# UNITED STATES PATENT AND TRADEMARK OFFICE

APPLICATION NO.	FILING DATE	FIRST NAMED INVENTOR	ATTORNEY DOCKET NO.	CONFIRMATION NO.
10/683,987	10/14/2003	Gerardo Y. Pablo	51299.0002 (Hart)	3100

**Office Action Summary**

**DETAILED ACTION**

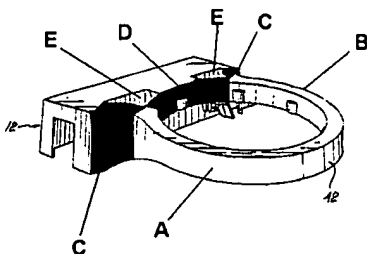
Levesque, however, also discloses a support having a clip portion (12) with arcuate ribs (A&B below) extending therefrom to form a retaining ring (42). Openings (E below) are formed in the support such that a pair of bridging portions (C below) attached to the clip portion (12) extend outwardly therefrom, interconnecting ribs (A&B below) to the clip portion. Also, an interior arcuate portion (D below) is formed between the pair of bridging portions, connecting the interior of the arcuate ribs to form the opening through which an object is secured in the support.

While Levesque is related to a flowerpot holder, Phetthaweebancha ('603) teaches the implementation of openings like those of Levesque on a bottle holder. Therefore, it would have been obvious to one having ordinary skill in the art at the time the invention was made to further modify the modified Phetthaweebancha ('333) device of either paragraph #7 or #8 above by forming a pair of openings in addition to the main opening, as taught by Levesque, using Phetthaweebancha ('603) as a motivating reference showing that such holes are known in the beverage holder art, the openings acting to reduce the amount of material required to form the beverage holder, in turn reducing the manufacturing costs.

Regarding claims 7-9, the protrusions of Levesque are shown to have a circular surface and are thus considered by the Examiner to be ellipsoids, either longitudinal or non-longitudinal, depending on which direction they are viewed from. It would have
